SNOWY MONARO
REGIONAL COUNCIL

Ordinary Council Meeting

8.1	Development Application 10.2022.60.1 Multi Dwelling Housing (4 Units) & Strata Subdivision	
	Attachment 1 DRAFT Reasons of Refusal and Statement of Reasons	2
	Attachment 2 Amended Architectural Plans	4
	Attachment 3 Revised Statement of Environmental Effects	43
	Attachment 4 Visual and Acoustic Privacy Impact Statement	67
	Attachment 5 Development Impact Assessment	82
	Attachment 6 BASIX Certificate (Updated).....	97
	Attachment 7 NatHERS 1 (updated).....	110
	Attachment 8 NatHERS 2 (updated).....	112
	Attachment 9 Letter From Alpine Law Regarding Easements/Restriction	120
	Attachment 10 DP 1228821 Plan & 88B Instrument	122
	Attachment 11 Original Architectural Plans	123
	Attachment 12 Statement Of Environmental Effects	158
	Attachment 13 Submissions	182
	Attachment 14 Submission Response	269
	Attachment 15 Submission Response Table	279
	Attachment 16 Response to Submissions received on Re-notified Plans.....	289

REASONS FOR REFUSAL

Figure 3: Location of tree island

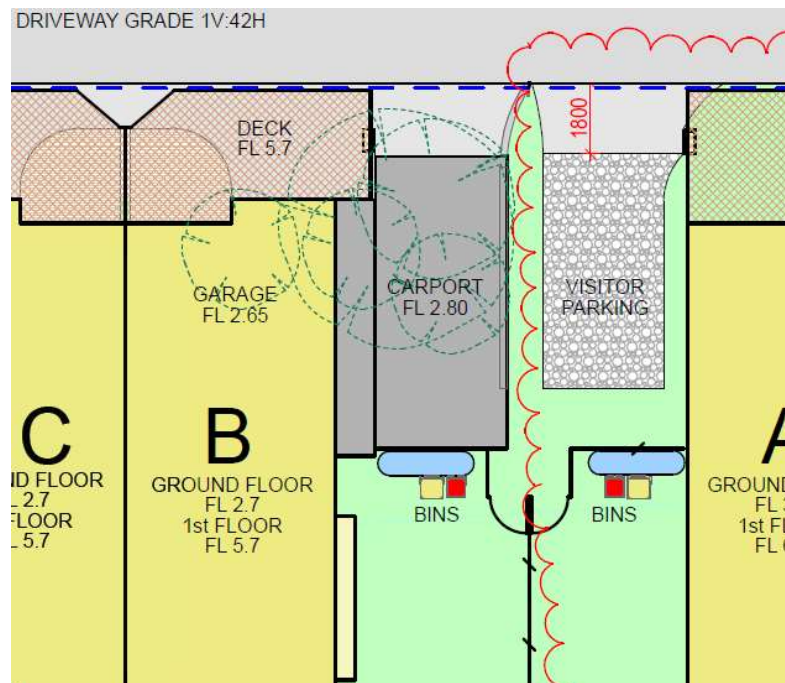
A healthy tree island exists in the location of dwelling B (**Figure 3**) and no justification has been provided to demonstrate that removal of this island is appropriate. This vegetation contributes to character and residential amenity and must be retained.

Figure 4: Poorly located visitor parking

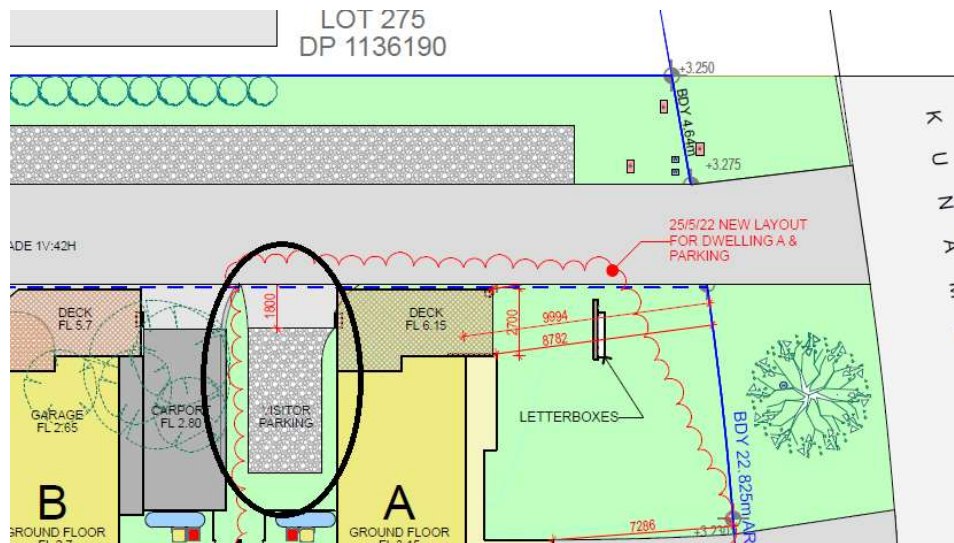
The location of visitor parking not appropriate (**Figure 4**). It presents as exclusive to the nearest unit, the space is not visible from street and it contains poor sight lines when reversing. Visitor vehicles have to enter the site (access driveway) to determine if the space is freely available. If the space is occupied there is not a designated turning area for a visitor to turn their vehicle around and exit safely in a forward direction. There are very poor sight lines when reversing out of the space due to the two storey development on either side. This impacts pedestrian safety.

Figure 6: One example of vehicles that hit garage walls and go over edge of driveway.

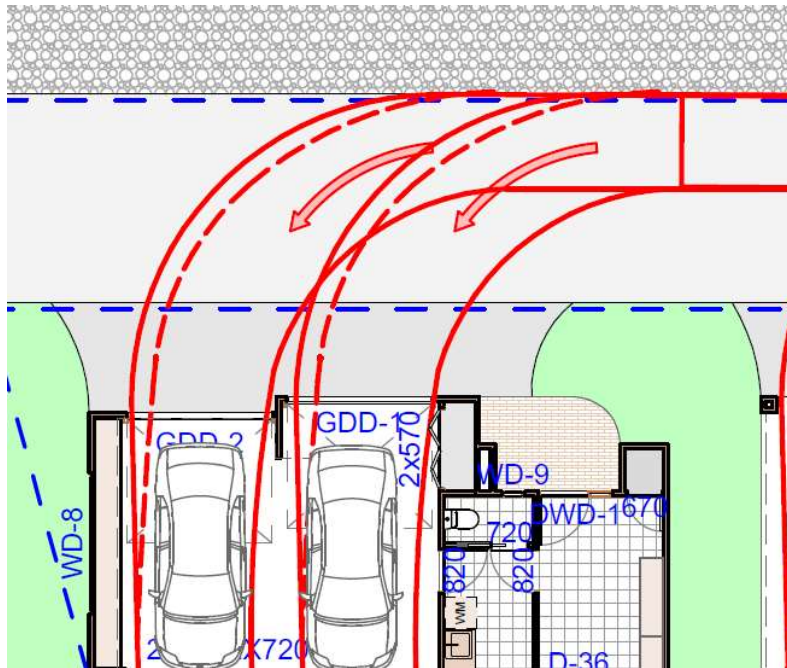
The vehicle turning templates are extremely tight and it is unclear if an appropriately sized vehicle in accordance with the relevant Australian Standard has been utilised. The diagrams show wheels of vehicle on (or over) the edge of the driveway and vehicles hitting garage walls and car port posts. The fact that there is insufficient room to complete vehicle turning movements safely is further evidence base that the proposed development is an overdevelopment of the site.

Figure 7: Overflow from absorption trenches discharges into adjoining property

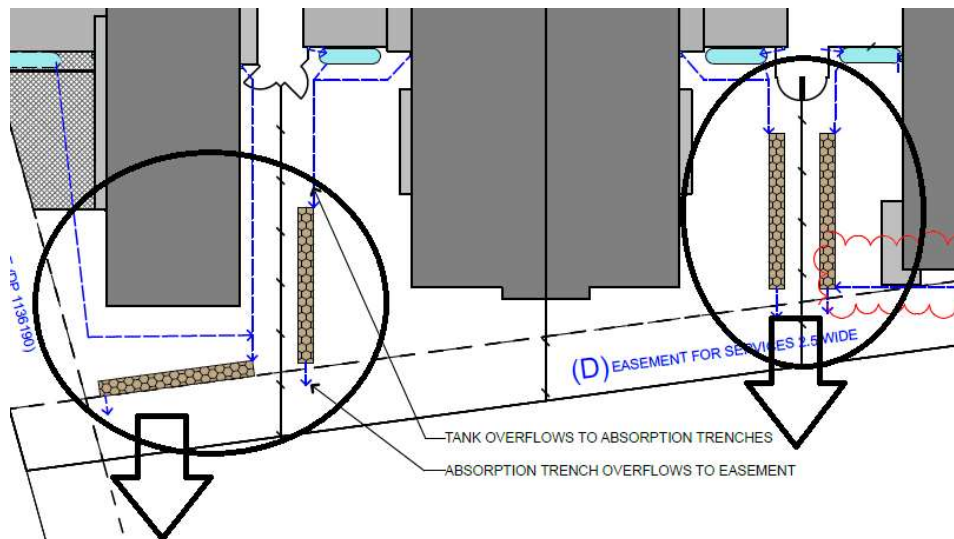
There is no stormwater easement and stormwater cannot be discharged to the street. Absorption trenches are proposed (**Figure 7**). However, in the absence of any detailed hydraulic and soil analysis the success of the trenches may not be able to be relied upon. Any overflow of stormwater will adversely affect down slope properties.

Figure 8: Prime morning sunlight for 32 Kunama Drive will be lost.

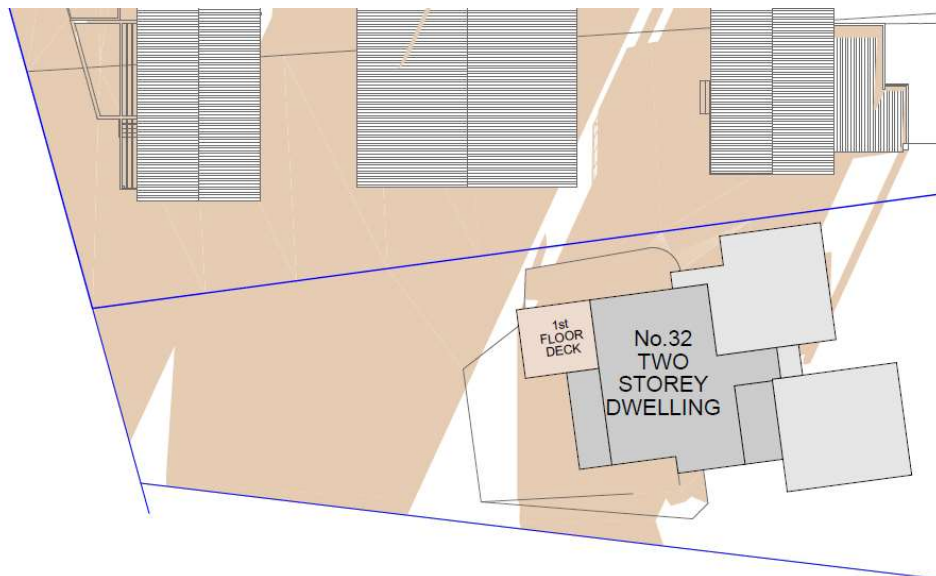
The proposed two storey dwellings limit solar access to outdoor areas and lower-level living areas of the neighbour at 32 Kunama Drive. The shadow diagrams show that most of the northern side of 32 Kunama Drive is in shadow all day (**Figure 8**).

The proposed dwellings are orientation North South which is inconsistent with the rest of dwellings in the street that are oriented East West toward the street frontage. In addition, 75% of the second storey floor area of the proposed development is located in the rear half of the allotment. This drastically impacts the residential amenity and exacerbates overshadowing impacts.
